Addendum No. 1

RE: Contract # C205036

Robeson County (U-5797)

SR-1997 (FAYETTEVILLE RD) FROM FARRINGDOM ST TO EAST 22ND ST

PROJECT REFERENCE NO.	SHEET NO.
U-5797	2B-6
R/W SHEET NO.	
ROADWAY DESIGN ENGINEER 	HYDRAULICS ENGINEER 
DOCUMENT NOT CONSIDERED FINAL UNLESS ALL SIGNATURES COMPLETED

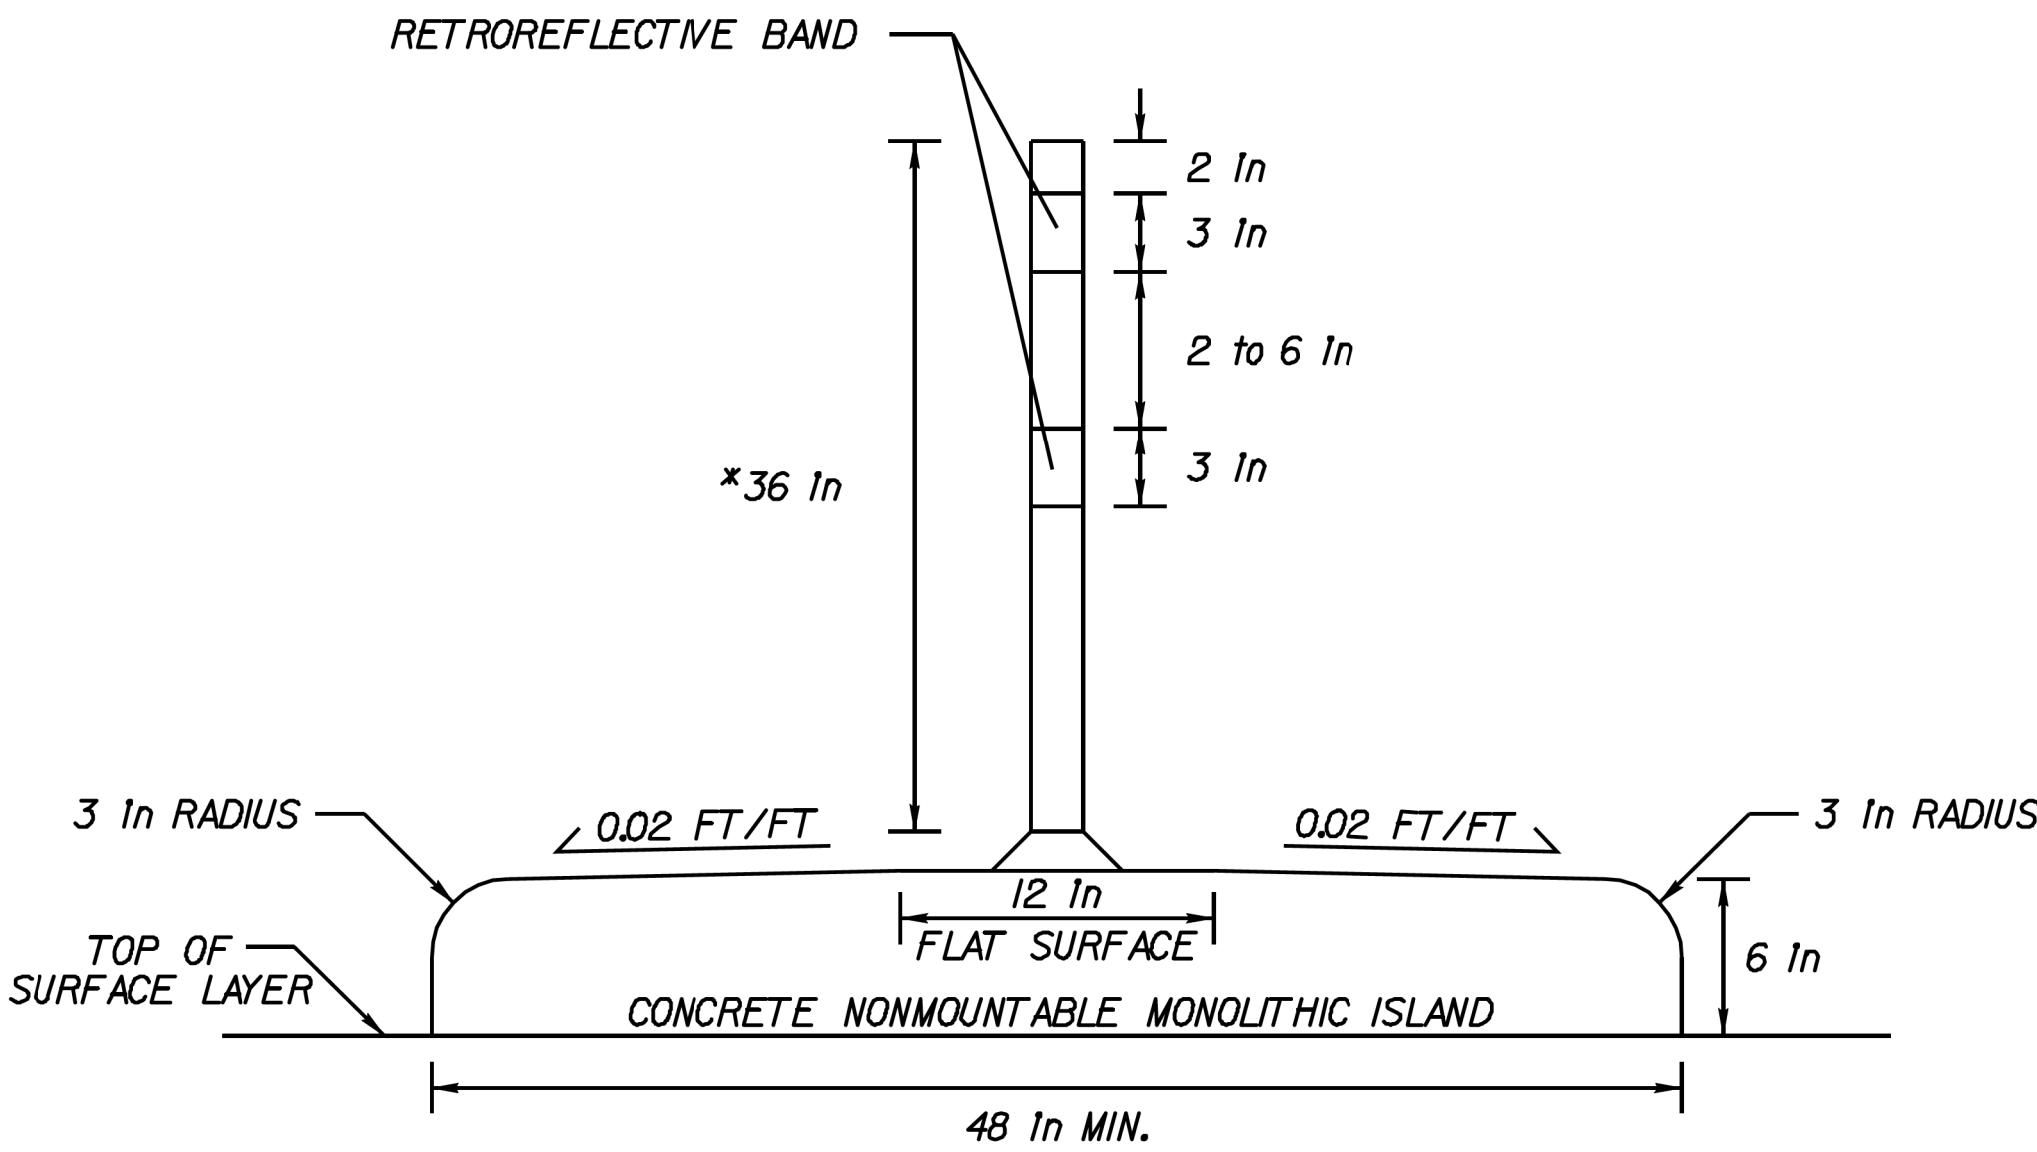
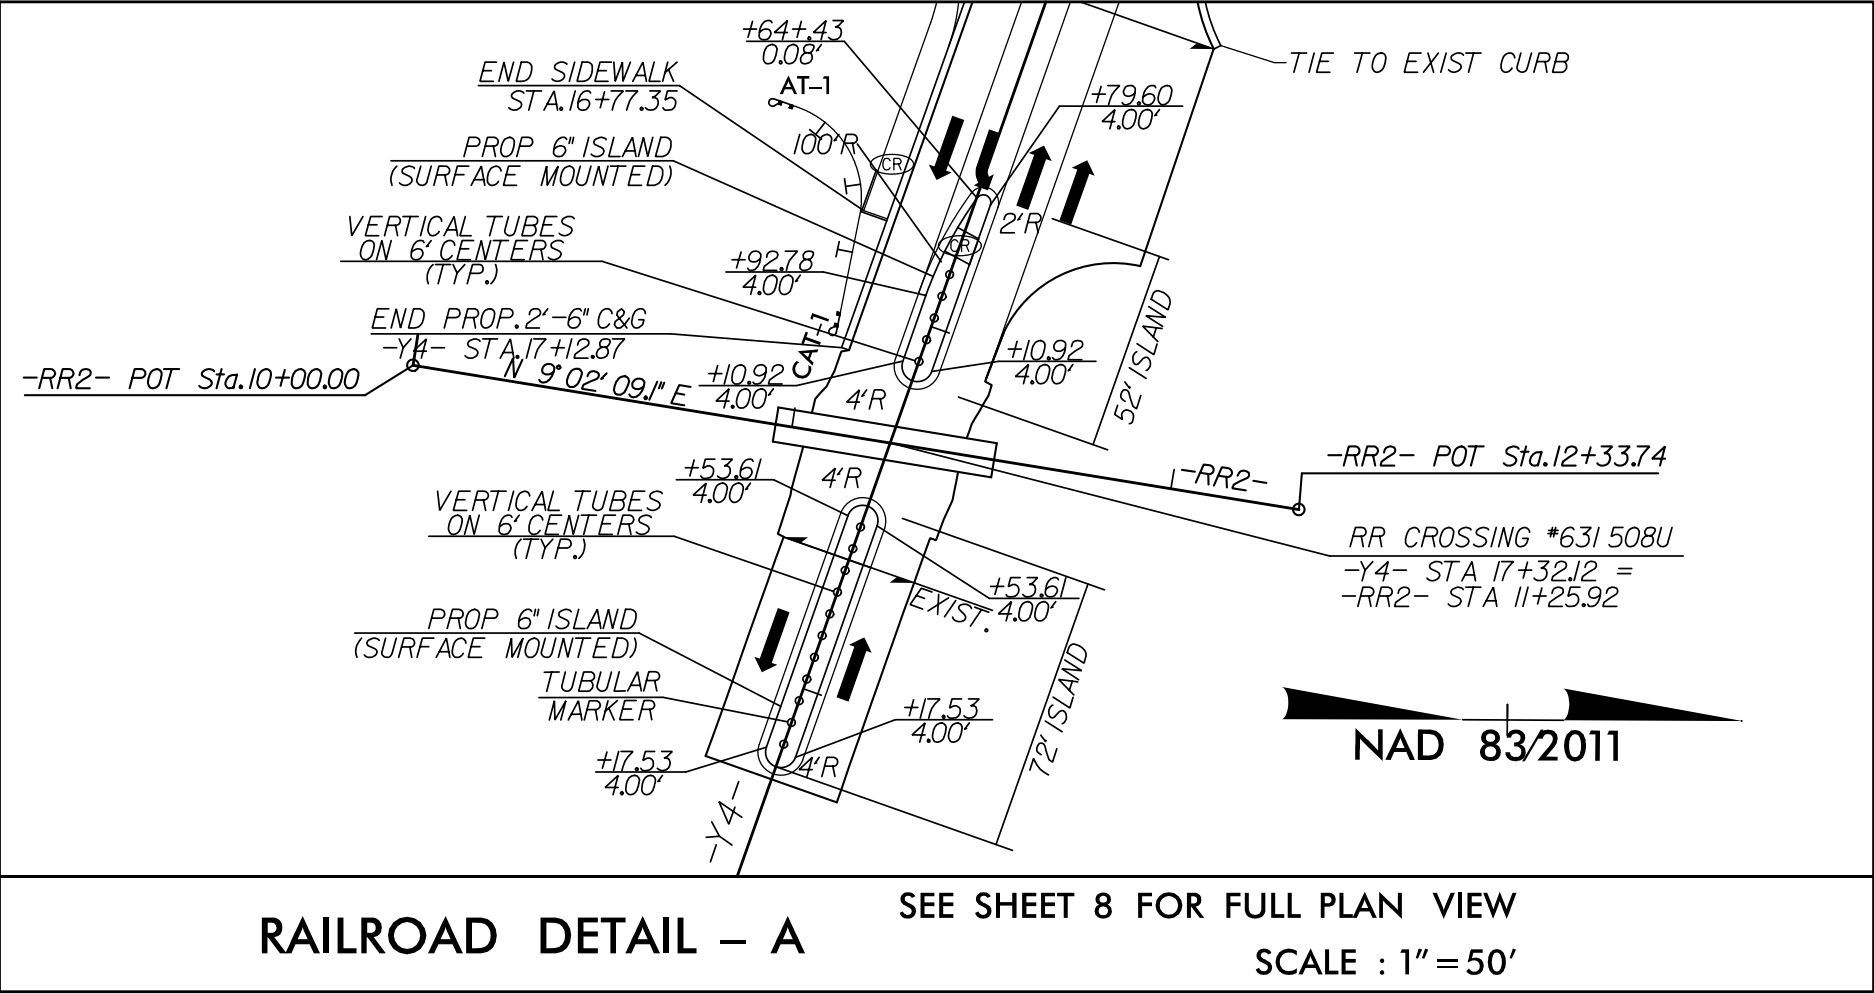
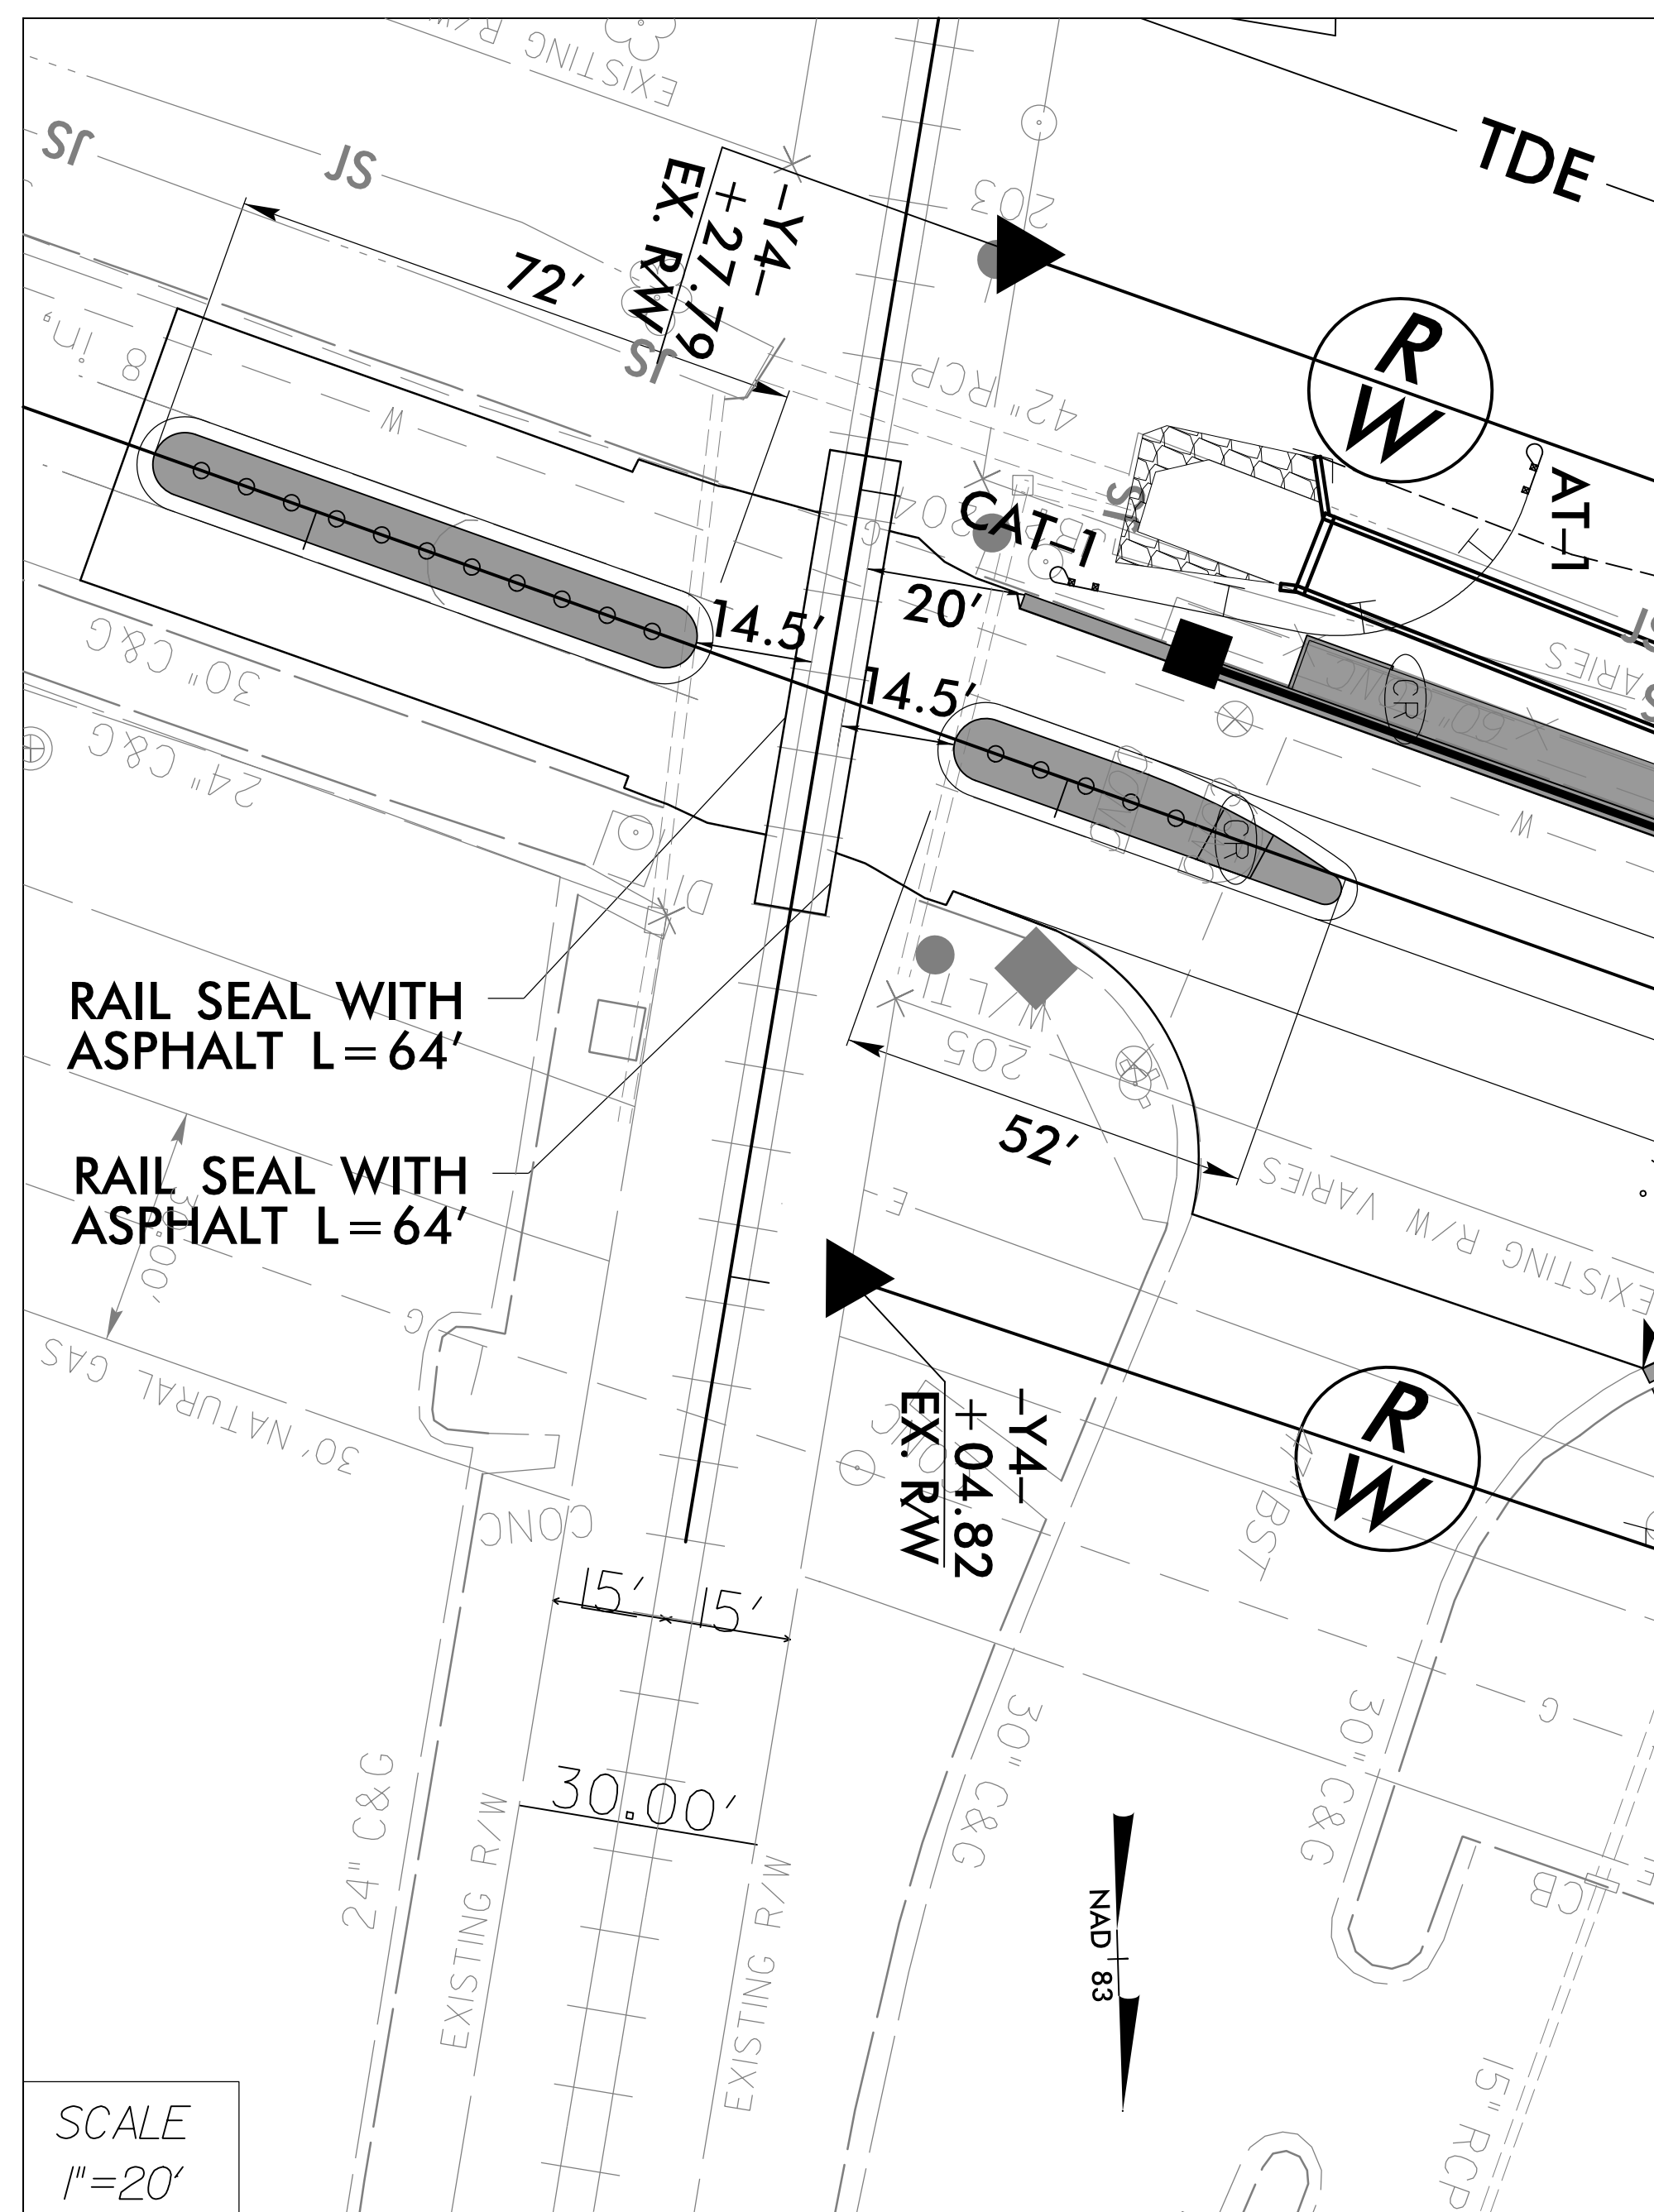
2B-2	Updated Intersection Detail D to match updated design
2B-3	Deleted the Roberts RR crossing from this sheet. Island shortened to be outside of Railroad ROW
2B-6	Deleted the Roberts RR crossing from this sheet. Island shortened to be outside of Railroad ROW
3B-1	Earthwork Updated for Y2 updates
3B-2	Pavement Removal Summary Updated
3D-11	• 1101 Box removed • 1101-1100 pipe removed • 1102 box removed • 1102-1101 pipe removed • 1103 box removed • 1103-1101 pipe removed • 1104 box removed • 1104-1101 pipe removed • 1105 box removed • 1105-1104 pipe removed • 1106 box removed • 1106-1105 pipe removed 1110 through 1114 pipes and boxes moved from sheet 3D-12 to sheet 3D-11
3D-12	• 1107 box removed • 1107-1104 pipe removed • 1108 box removed • 1108-1104 pipe removed • 1109 box removed • 1109-0674 pipe removed Lines shifting up
3D-13	• Y2 36+37 Flowable fill removed • Y2 35+57 and Y2 34+71 pipe removal removed
